FILING NO. 4  
ROADWAY & STORM IMPROVEMENT PLANS

TRAILS AT ASPEN RIDGE			
FILING NO. 4 ROADWAY & STORM IMPROVEMENT PLANS			
ROADWAY PLAN & PROFILE			
DESIGNED BY:	CAG	SCALE	DATE ISSUED:
CHECKED BY:	NMS	HORIZ 1"=40' VERT. 1"=8'	JUNE 2021
SHEET			5 OF 32
RD01

TRAILS AT ASPEN RIDGE				
FILING NO. 4 ROADWAY & STORM IMPROVEMENT PLANS				
STORM DRAIN PLAN & PROFILE				
DESIGNED BY: JTS	SCALE: HORIZ. 1" = 40'	DATE ISSUED: JUNE 2021	DRAWING No. SD01	
DRAWN BY: BAS	VERT. 1" = 5'	SHEET 24 OF 32		
CHECKED BY: NMS

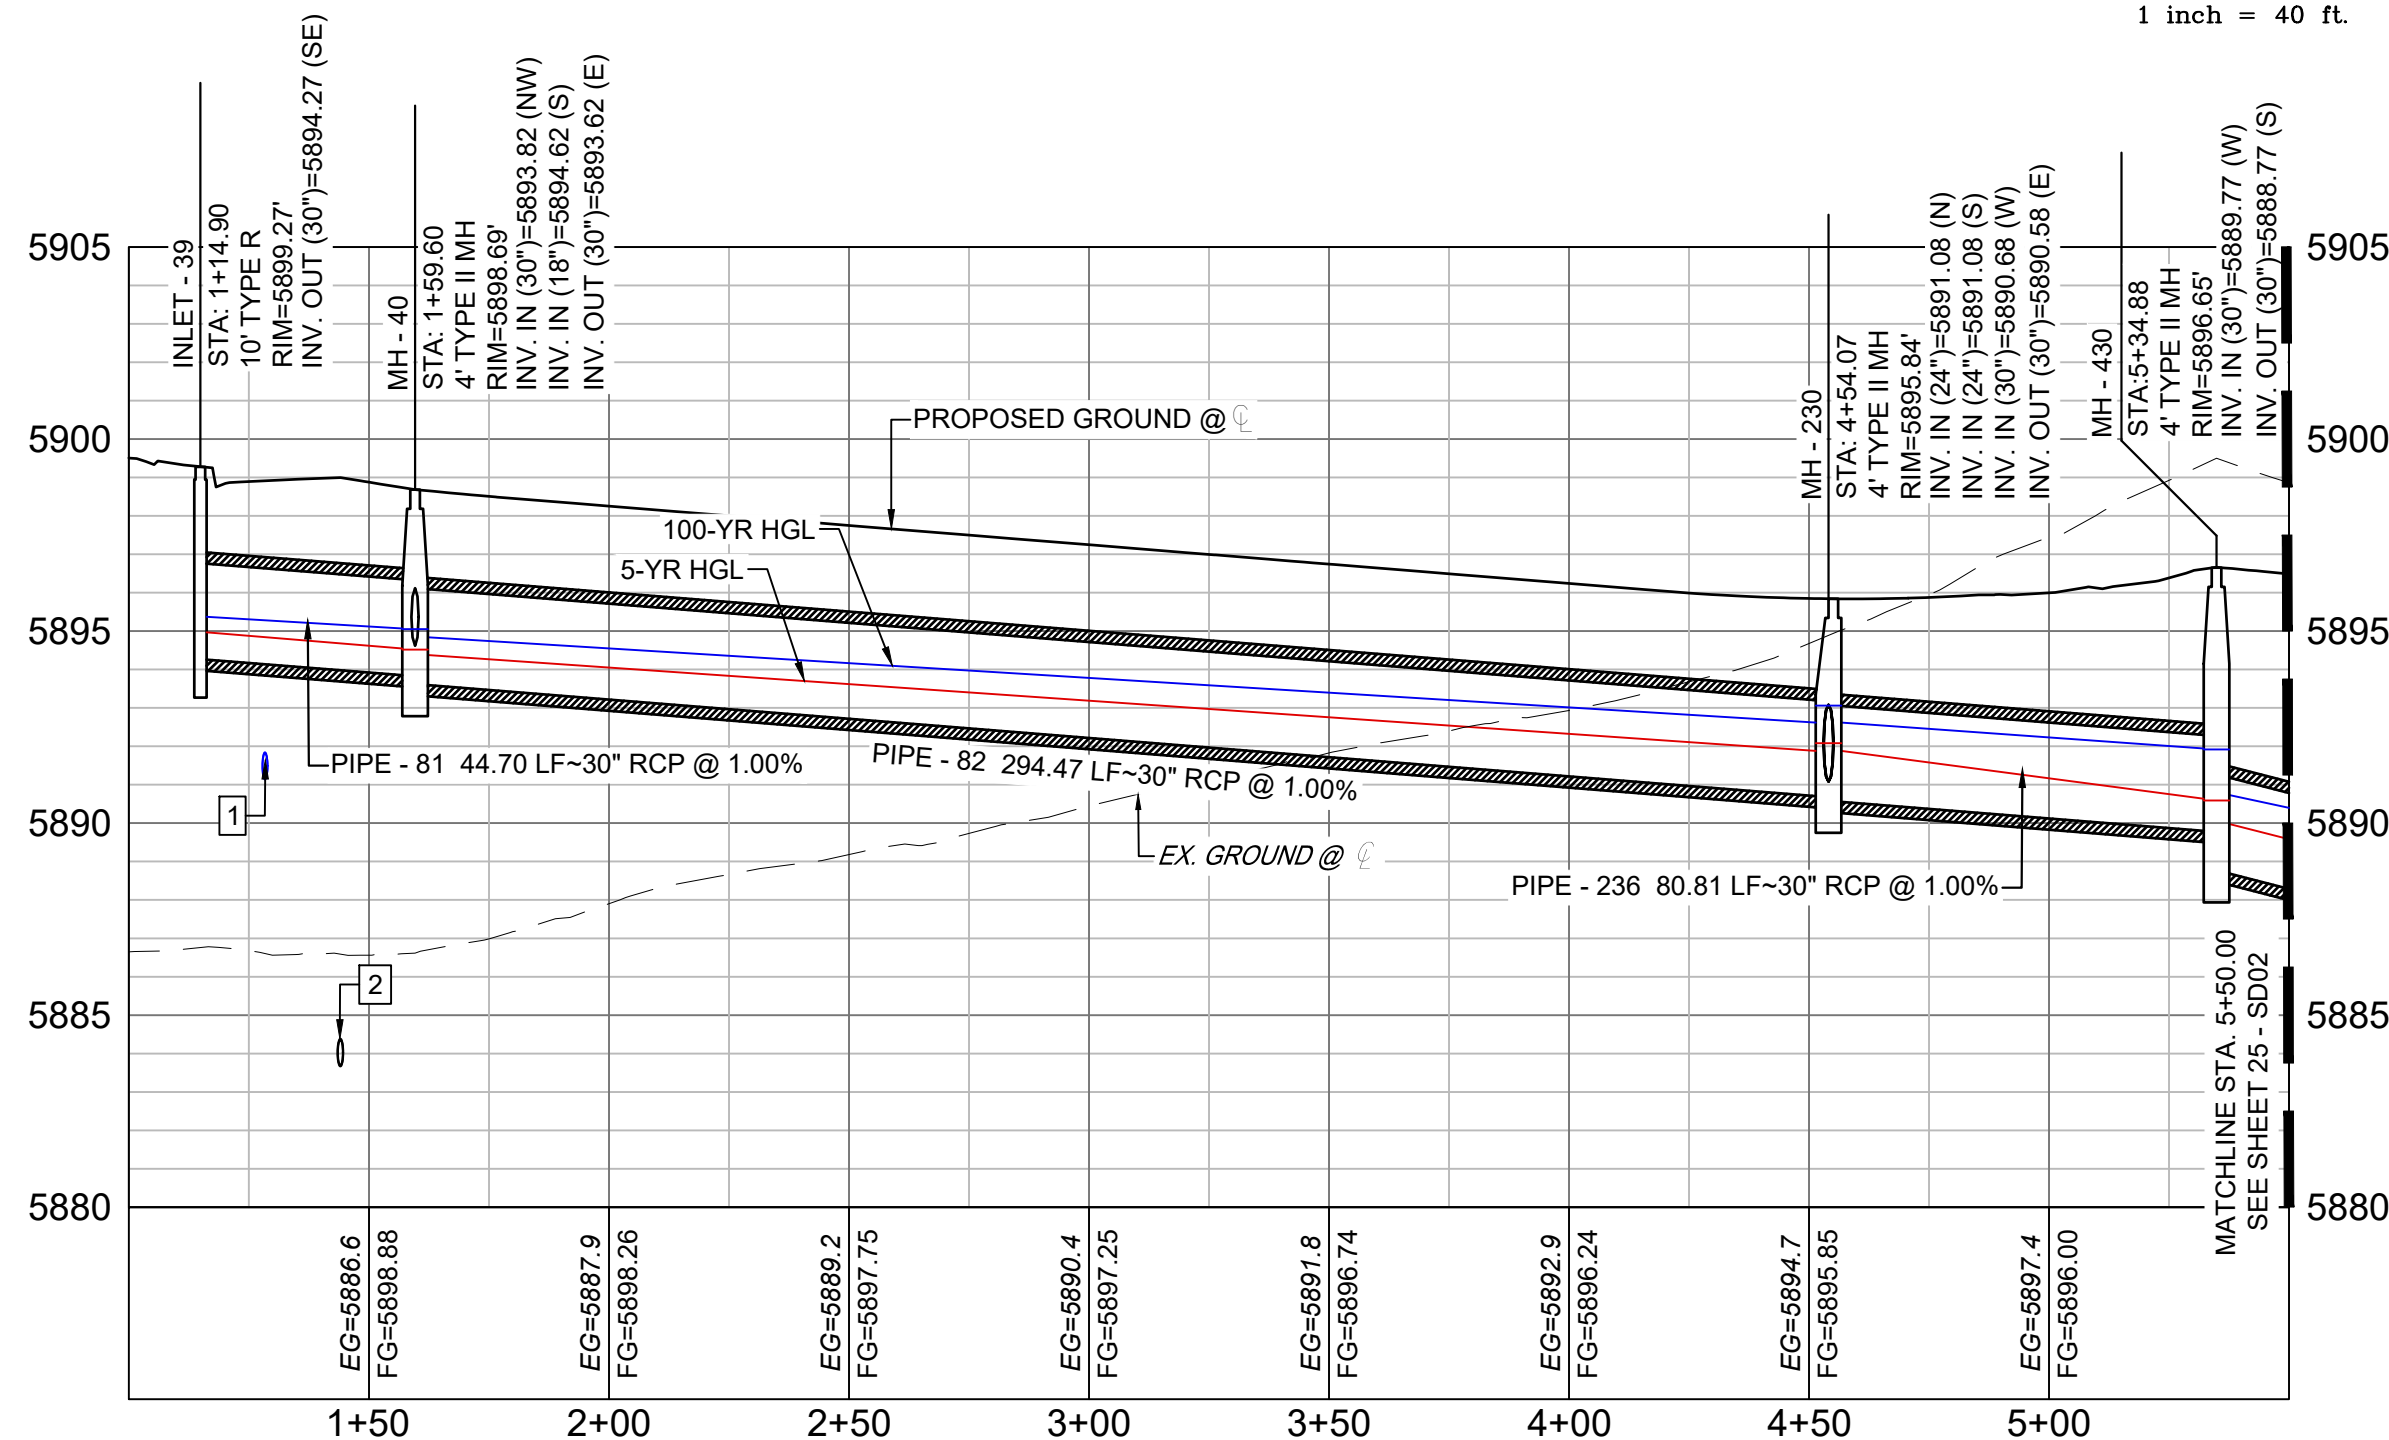
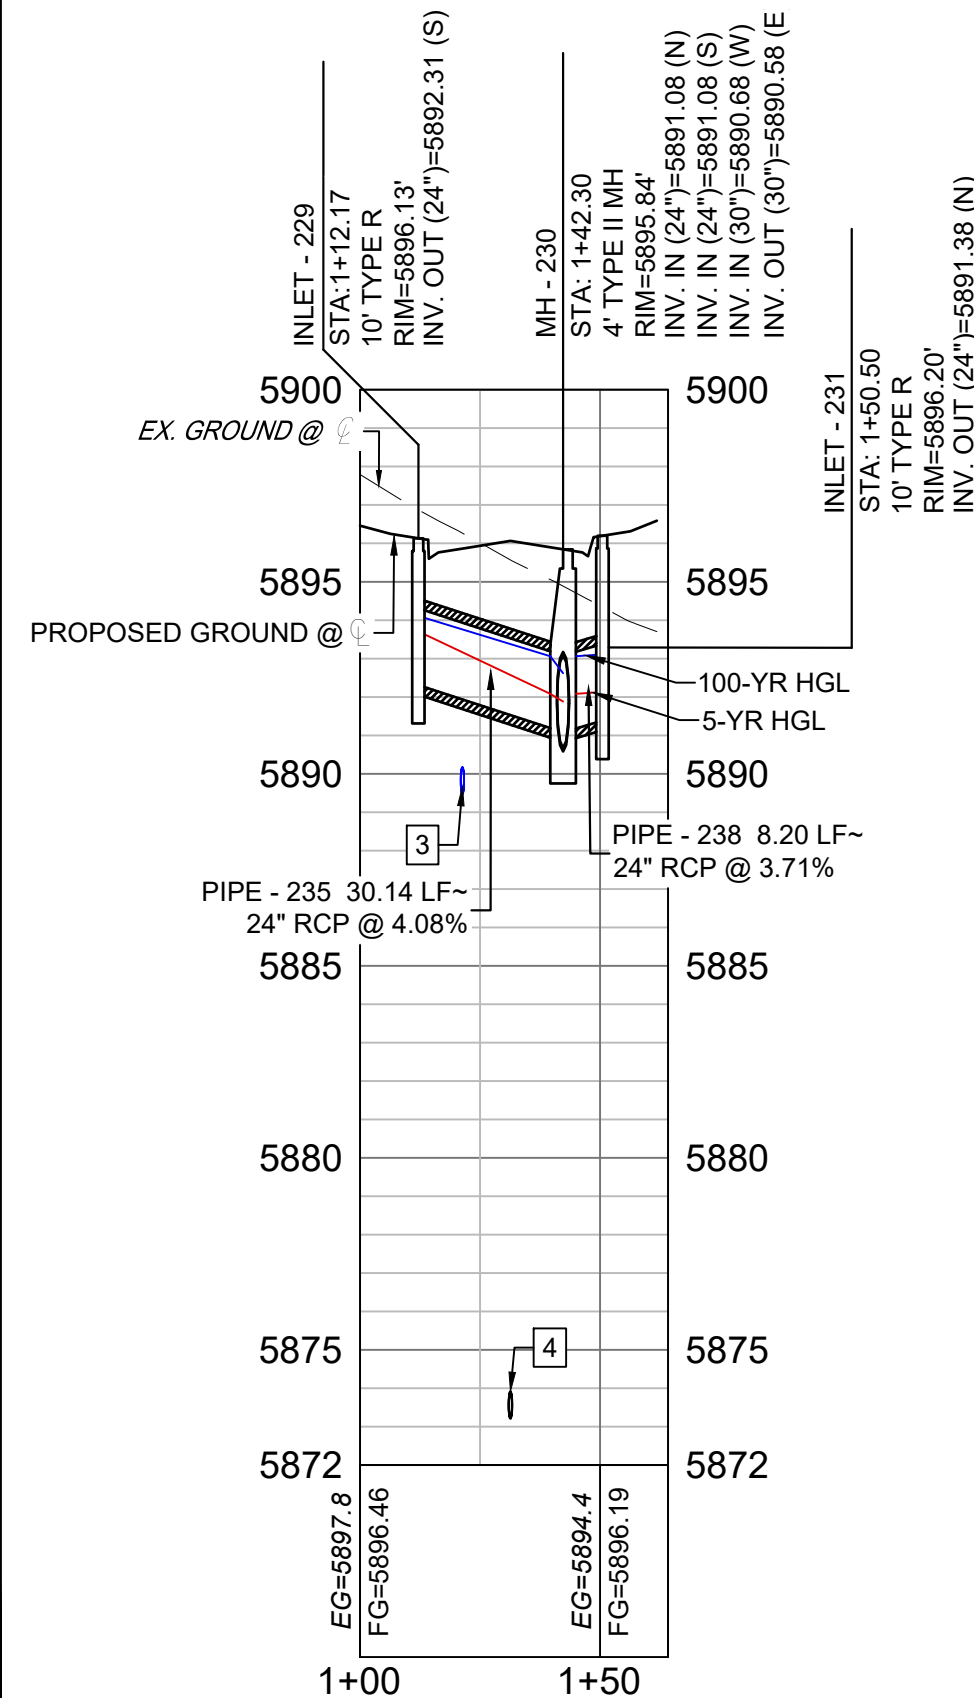
Label P&P as either public or private.  
System within the ROW will be public

TRAILS AT ASPEN RIDGE			
FILING NO. 4 ROADWAY & STORM IMPROVEMENT PLANS			
STORM DRAIN PLAN & PROFILE			
DESIGNED BY:	JTS	SCALE	DATE ISSUED:
DRAWN BY:	BAS	HORIZ. 1" = 40'	JUNE 2021
CHECKED BY:	NMS	VERT. 1" = 5'	25 OF 32
			DRAWING No. SD02

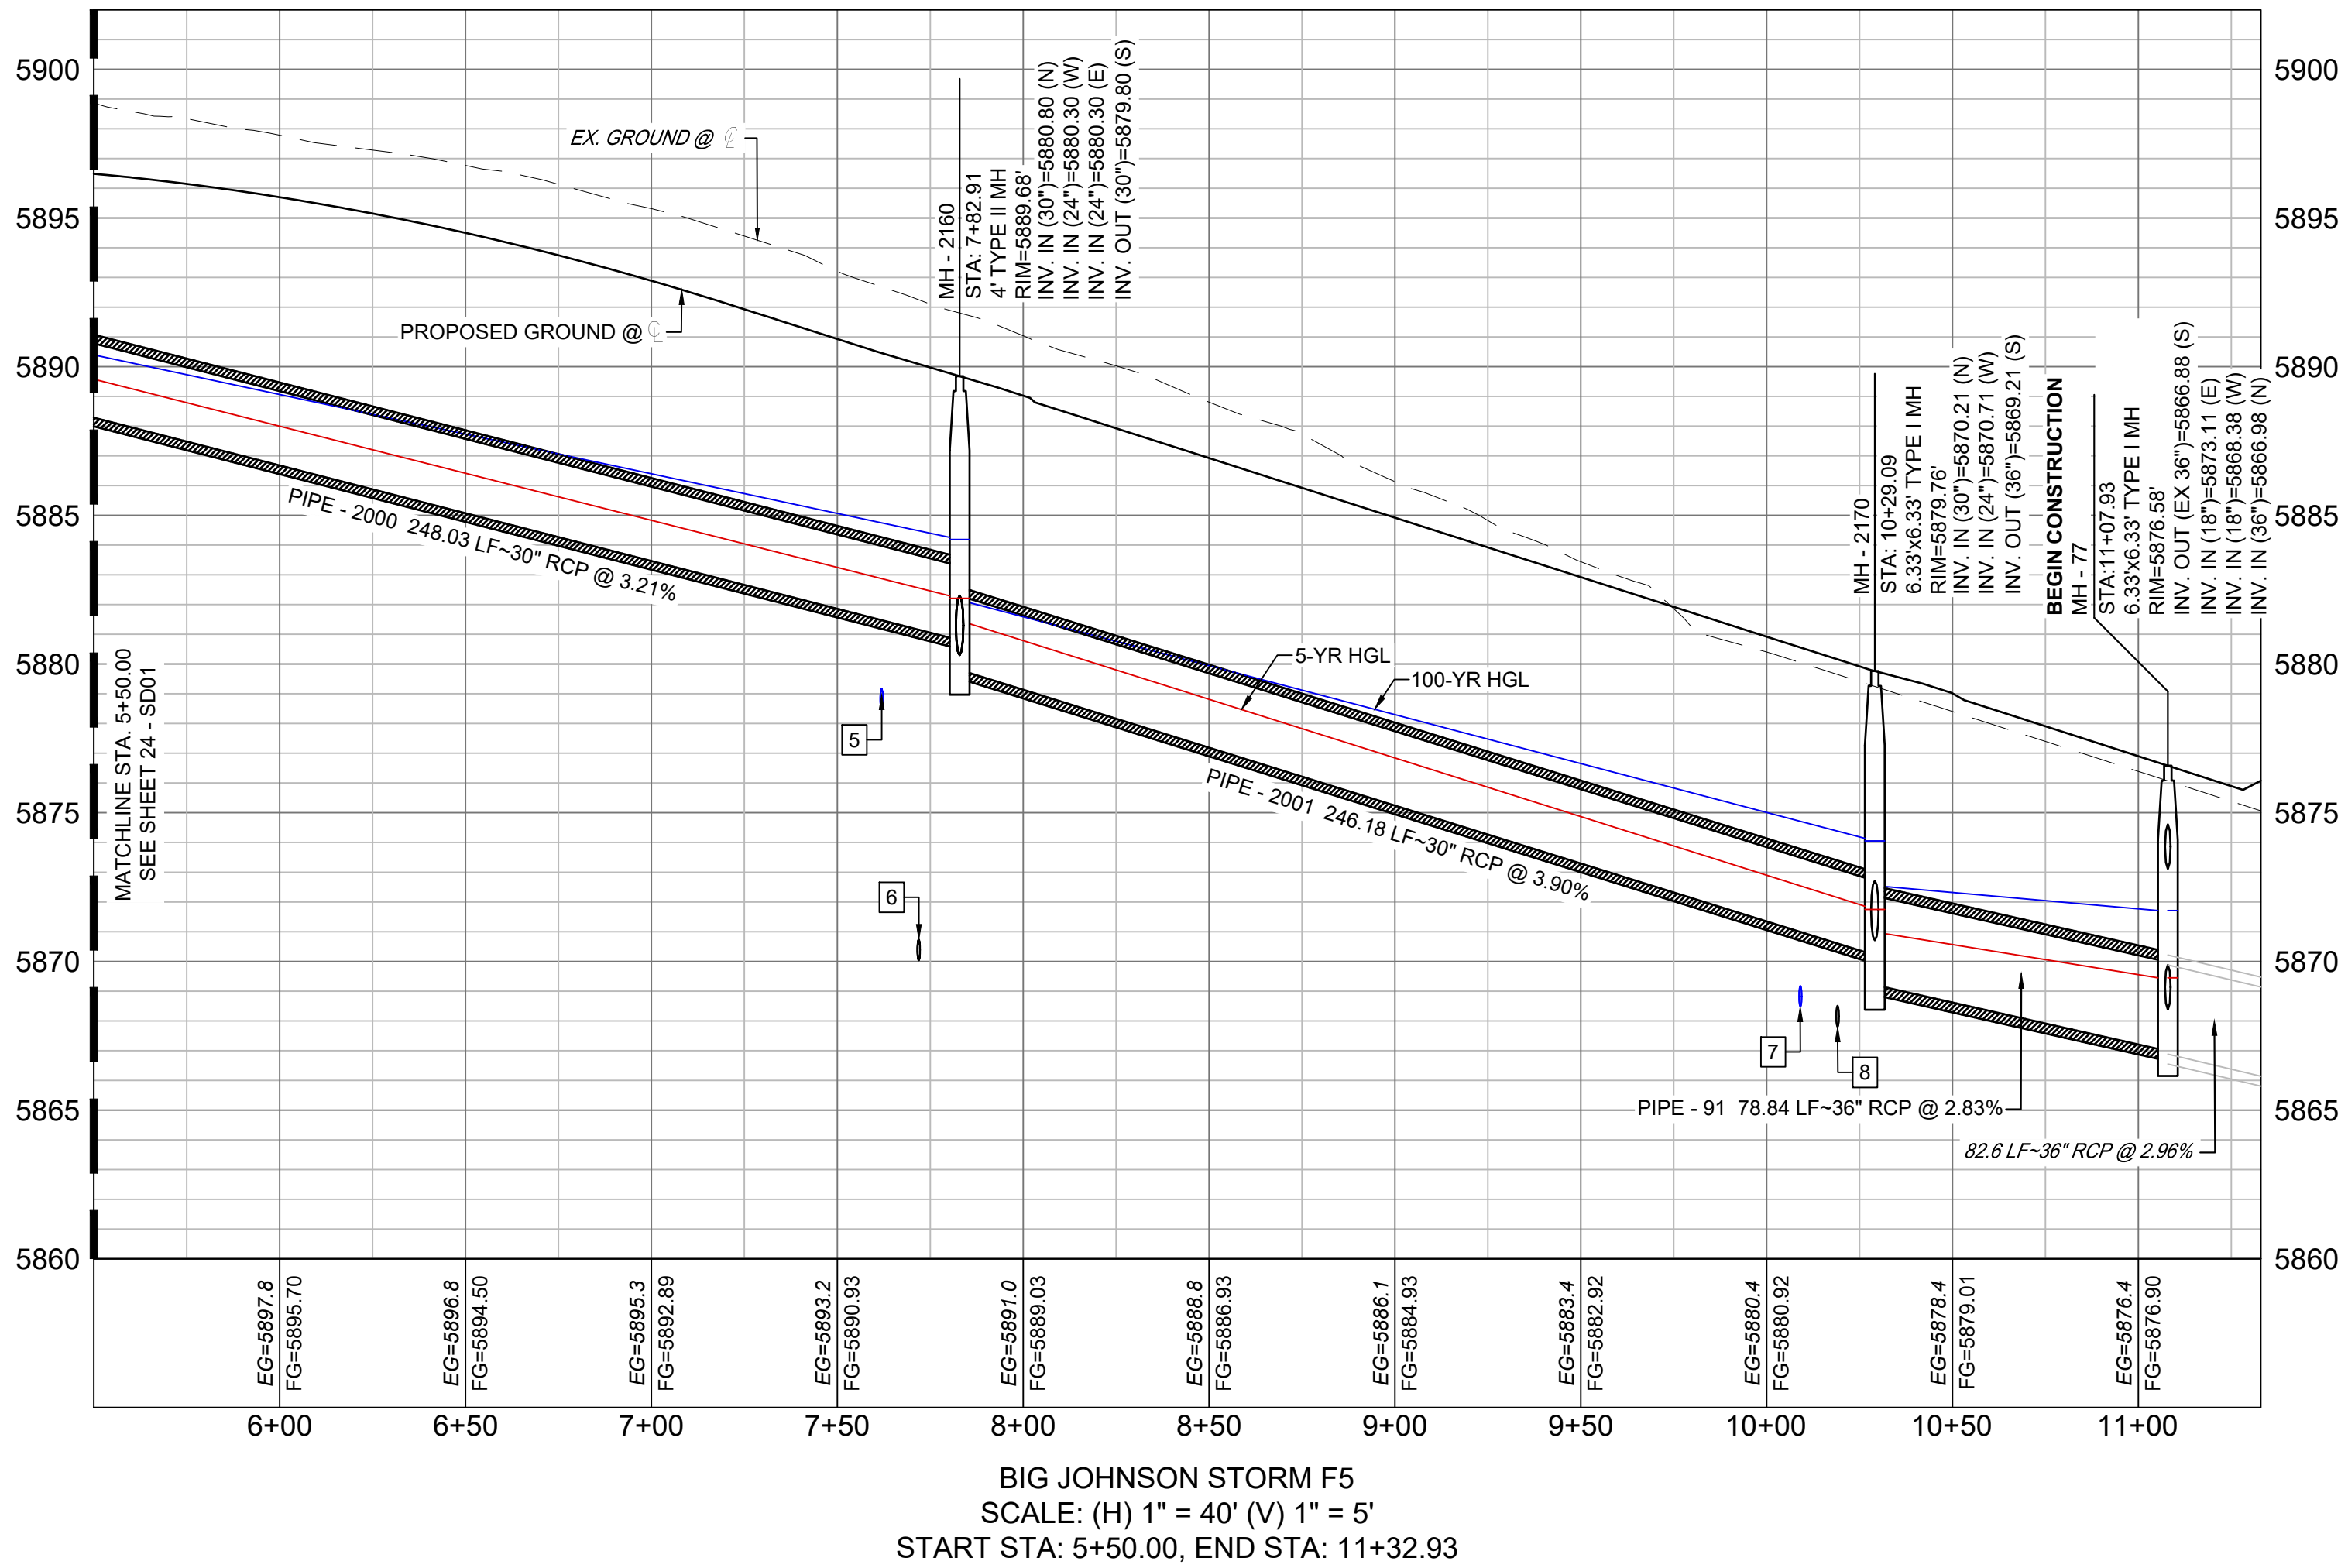
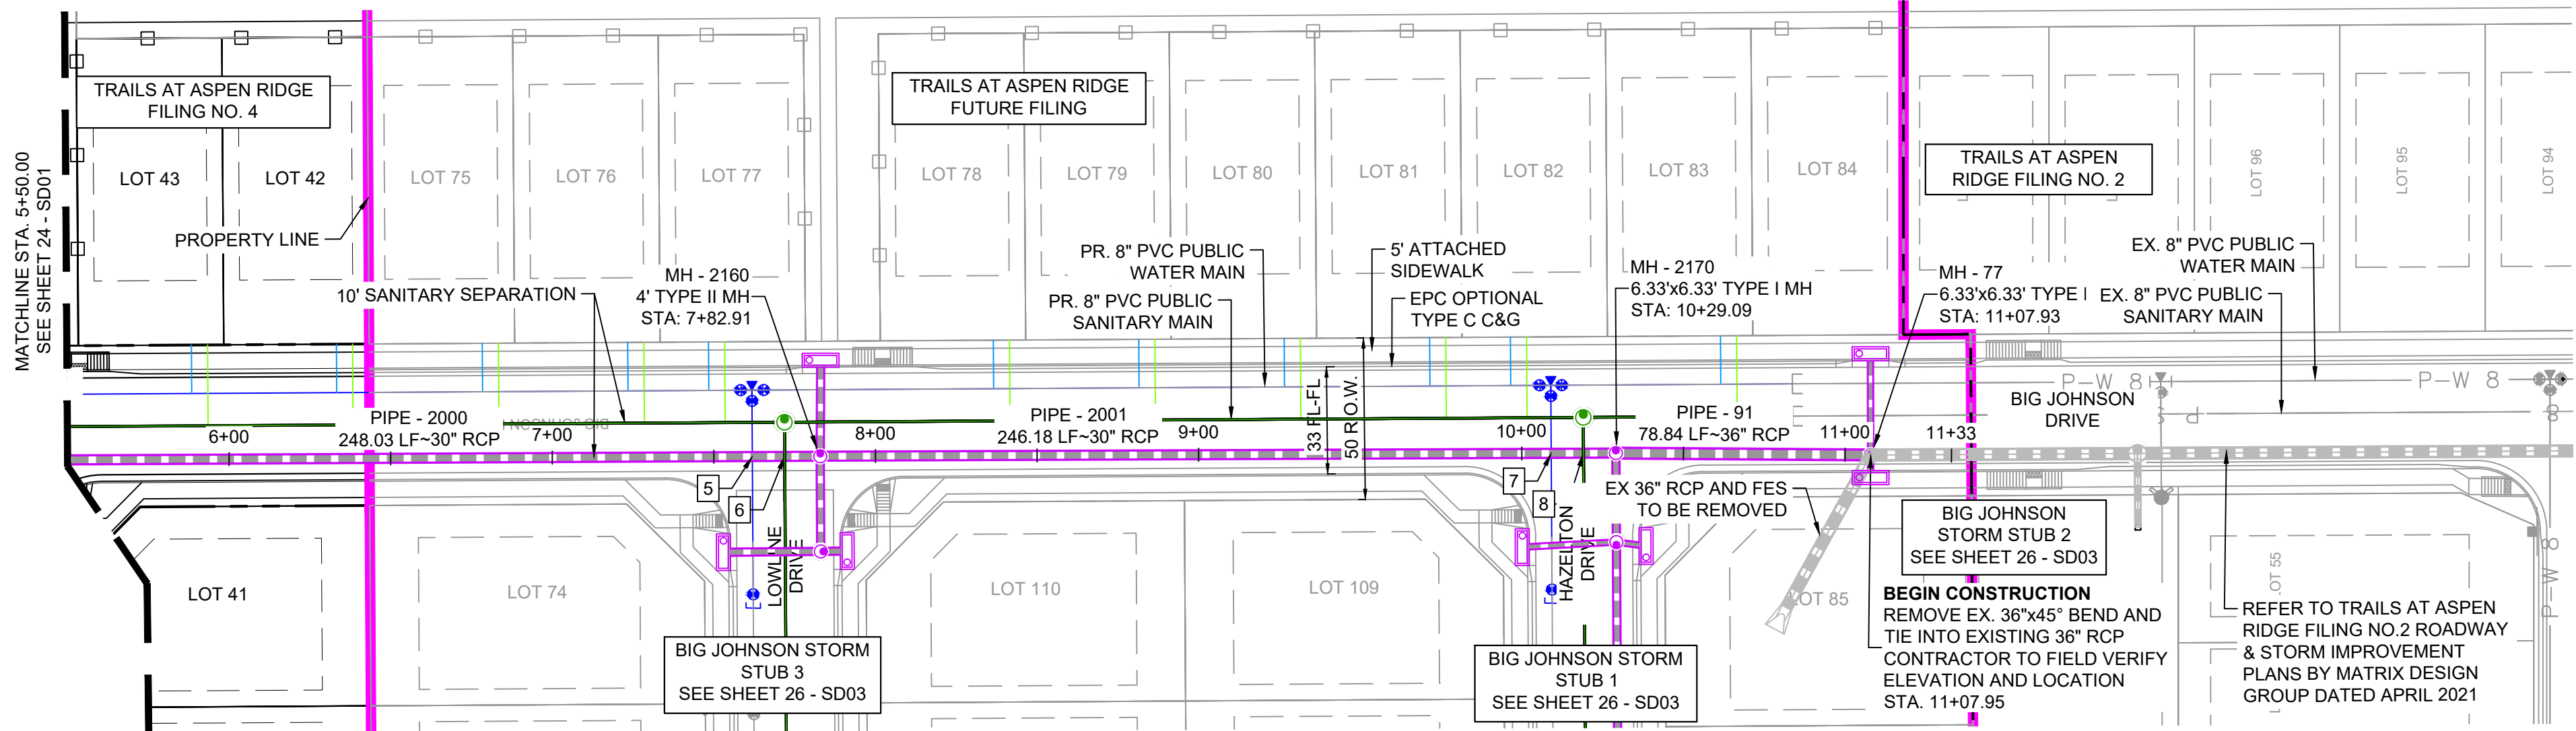
Add the following note:  
Sections of storm pipe with pressure head during the 100yr storm shall use watertight joints with a 100 yr service life per ECM 3.3.1.D
